PUBLIC MEETING OF  
U.S.NRC-STONE & WEBSTER-CONSUMERS POWER COMPANY

MR. HARRISON: Good morning. I would like to welcome all of those present to the Stone & Webster, NRC, Consumers Power meeting.

14 I would like to turn the meeting over to Mr. Lucks  
15 so he can give us his presentation on the soil areas.

Item 49-11 - E/W8 Grillage Lower Bearing Plates/Cap Beam Fit-up.

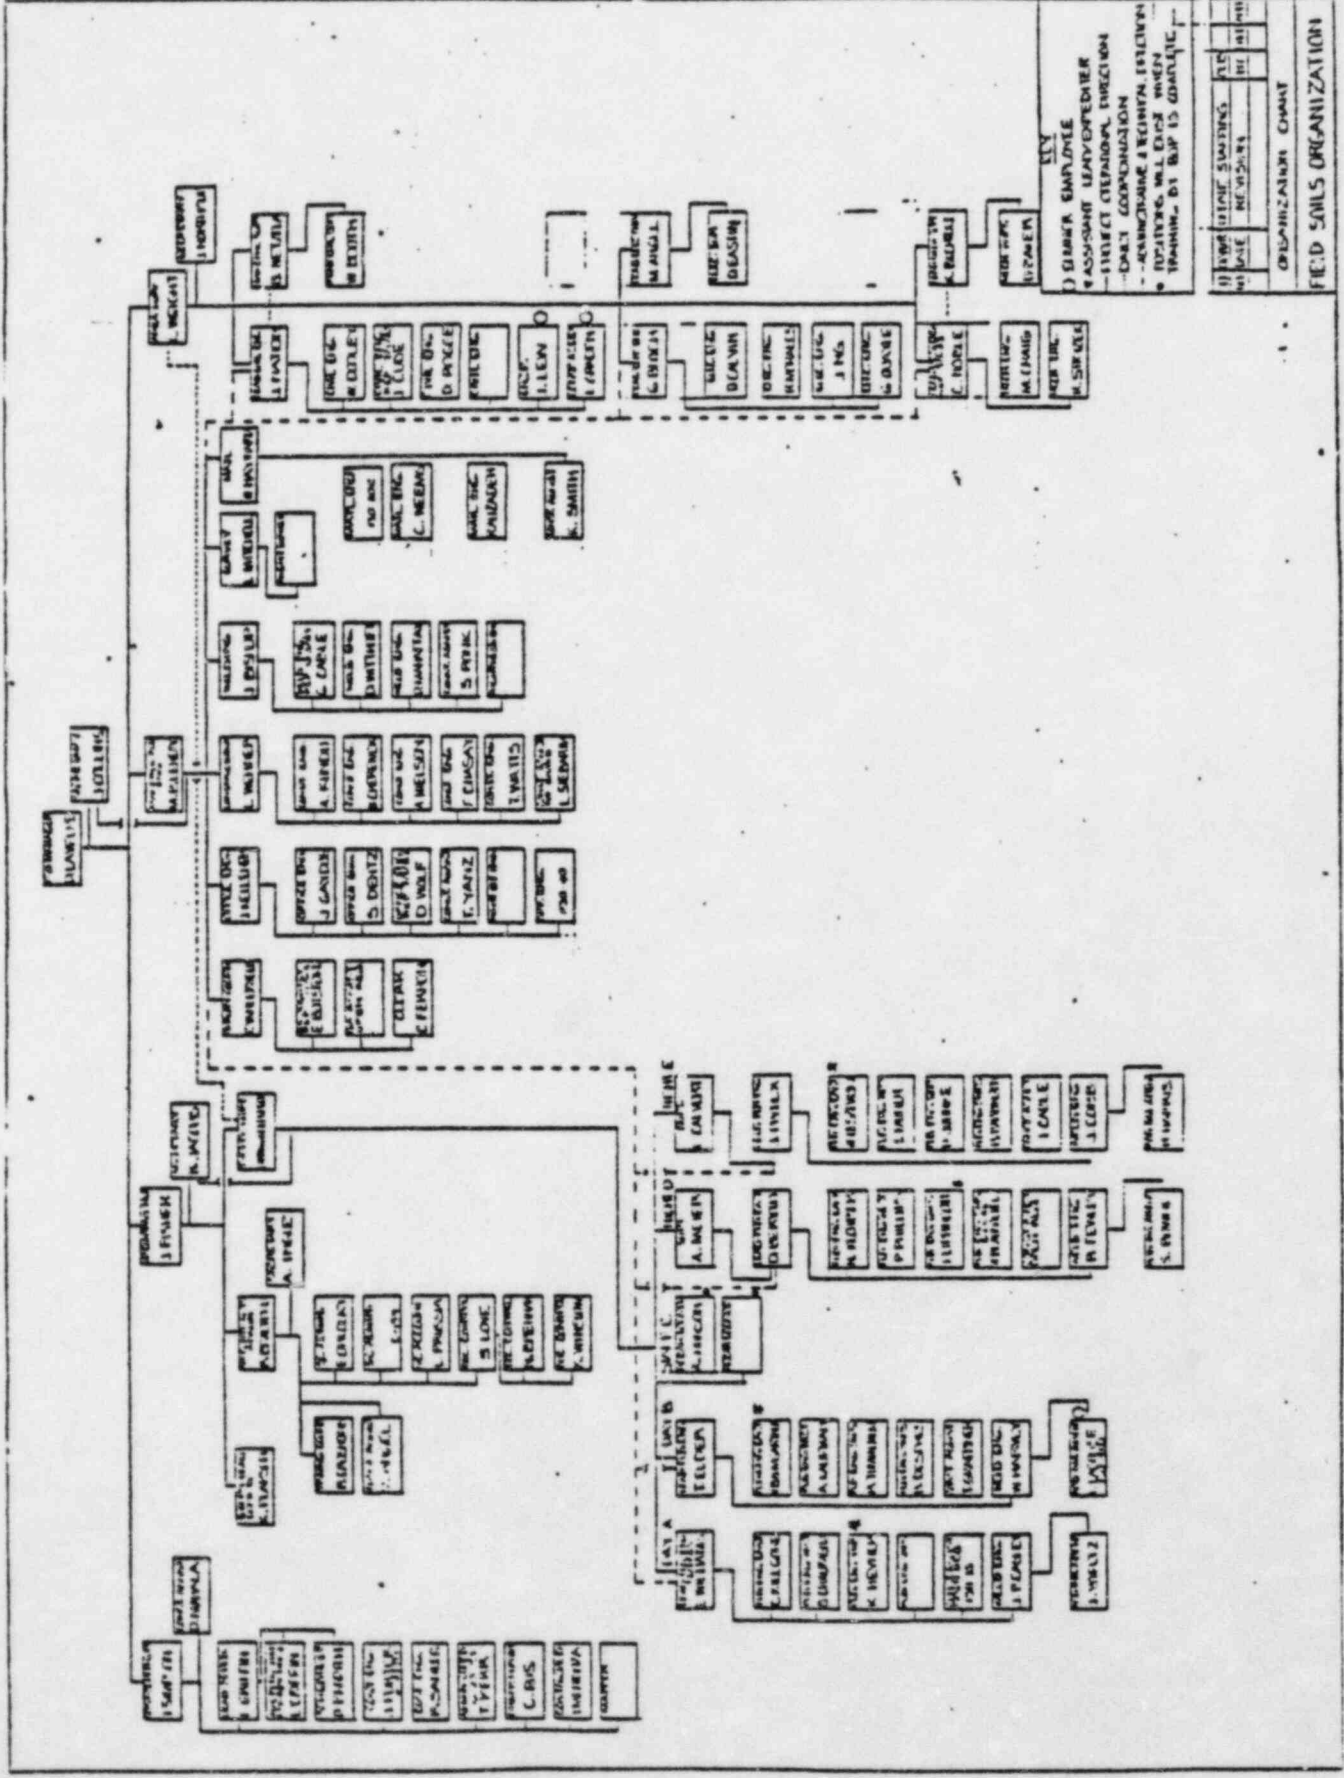
A. Scott noted that the bearing plates resting on the cap beams do not bear uniformly. E. Cvikl will review the requirement. ( OPEN ITEM )
